ATTACHMENT 2 - PRCUTS IMPLEMENTATION PLAN OUT OF SEQUENCE COMPLIANCE TABLE

The subject site is outside the PRCUTS '2016 - 2023 Release Area' which means that the redevelopment of the site should be in the medium to long term between 2024 and 2054. Proposals that depart from this staging need to be considered against the PRCUTS 'Out of Sequence Checklist' to ensure that changes to the land use zones and development controls can be justified against the underlying Principles and Strategic Actions of the Strategy. These include provision of necessary transport, services and social infrastructure to service a new population. The Checklist also aims to ensure the established benchmarks for the quality of development and public domain outcomes desired for the Corridor are achieved.

Image 4 - Extract from proponent's urban design scheme indicating the proposed building envelope

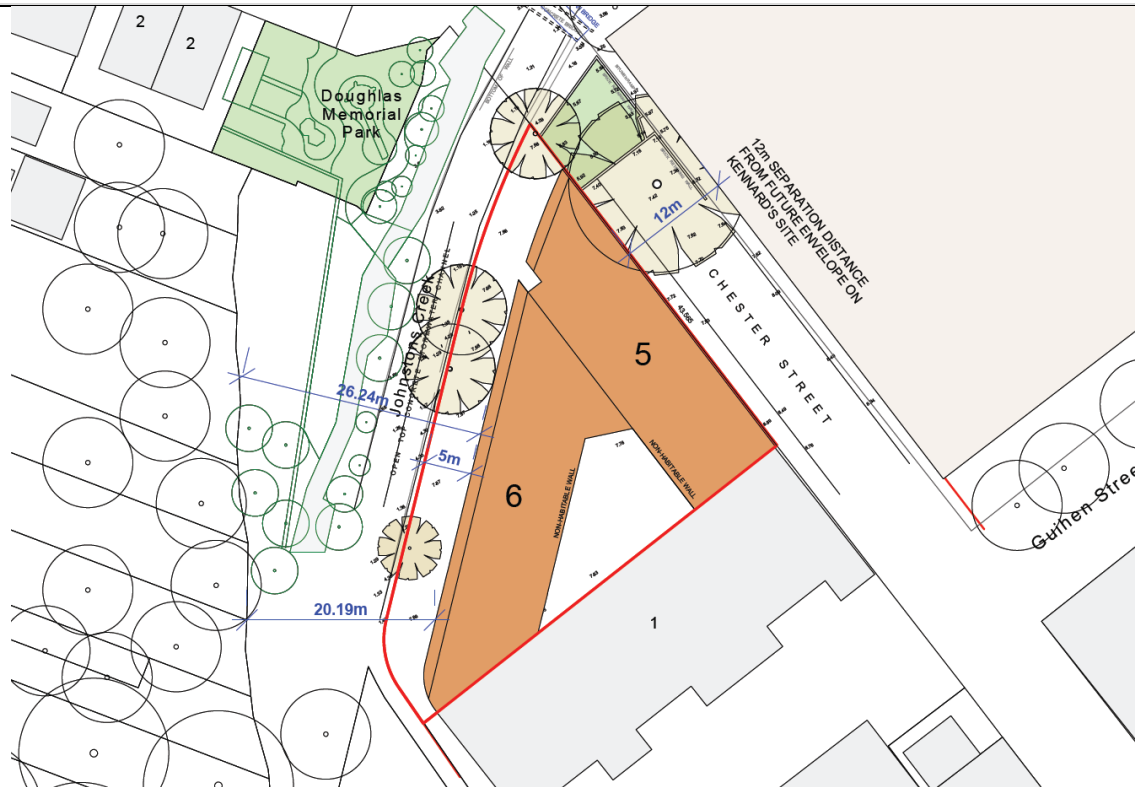
3. *Preserve the green pocket parks at the termination of Johnstons Creek Stormwater Channel No 55* - There is an existing pocket park at the end of Chester Street. The proposed triangular layout of the building results in hard edges/ poorly splayed corners at the interface between the existing park and the proposed building which is partially due to the irregular shape of the site (Refer to the image below). There is an opportunity to remodel the building layout by providing increased setbacks and deep soil planting at the northern interface which could soften the visual impact and enhance the amenity of the existing pocket park. The proponent's design does little to preserve/ enhance the green pocket park and is inconsistent with this objective.

Image 5 - Open space and Active transport map. Map anomaly highlighted in black box.

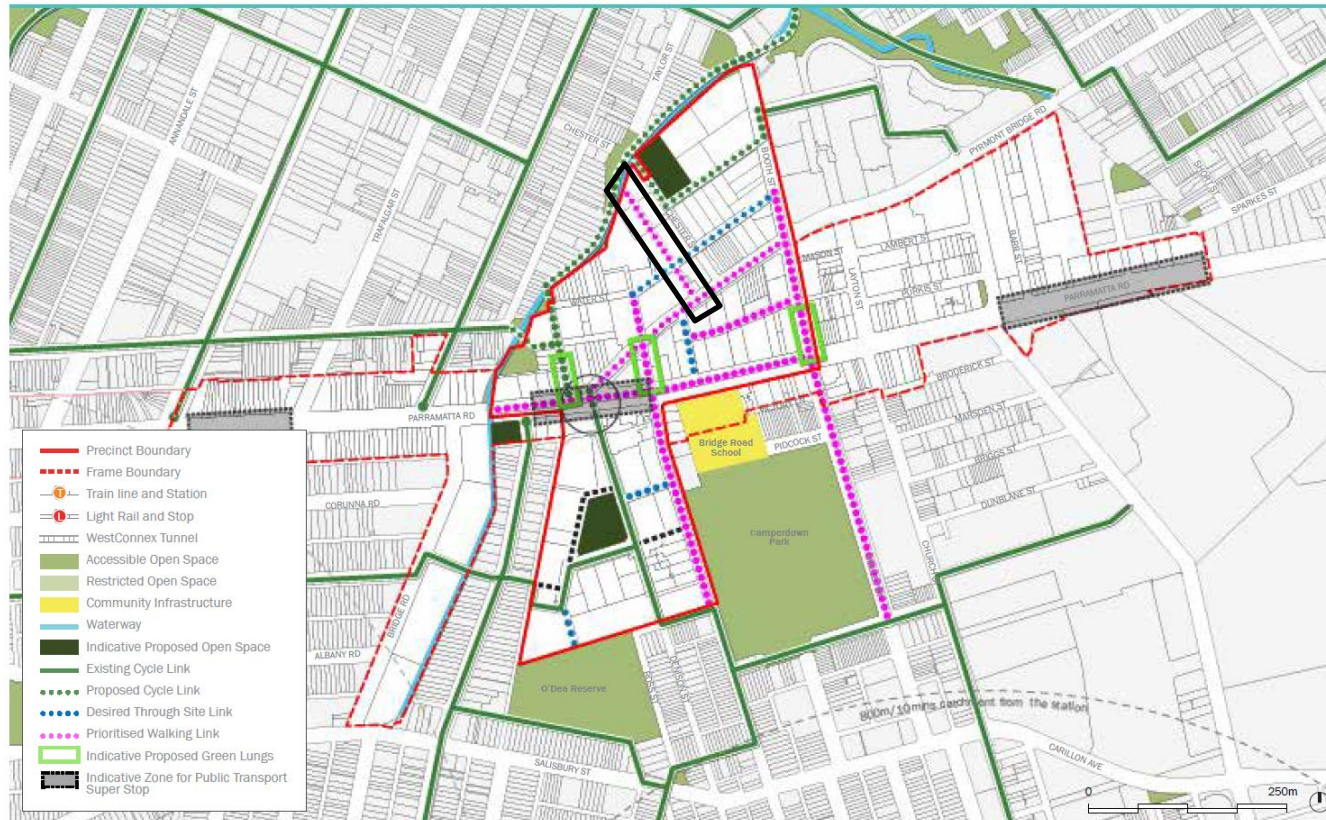
- *Implement the Sydney CBD to Parramatta Strategic Transport Plan:* The proposed Camperdown Open Space and Transport Plan (as shown in the image below) identifies a new Prioritised Walking Link between Johnstons Creek and Pyrmont Bridge Road through the subject site and adjoining sites. This is considered to be an anomaly in the map as the supporting text in the Precinct Transport Plan identifies 'Johnston's Creek to Pyrmont Bridge Road along Chester Street' (p. 177) as a Prioritised walking link where high pedestrian activity would be located.

For Chester Street to function as a successful prioritised walking link, public domain improvement works such as footpath widenings, new streetscape plantings to enhance Chester Street's amenity and streetscape are desirable. The Planning Proposal is inadequate in this regard as it does not contribute to making Chester Street as a vibrant street.

Furthermore, the Strategy identifies Johnstons Creek corridor from Booth Street to Parramatta Road as a future Strategic Cycle Link and this has not been adequately addressed in this Proposal.
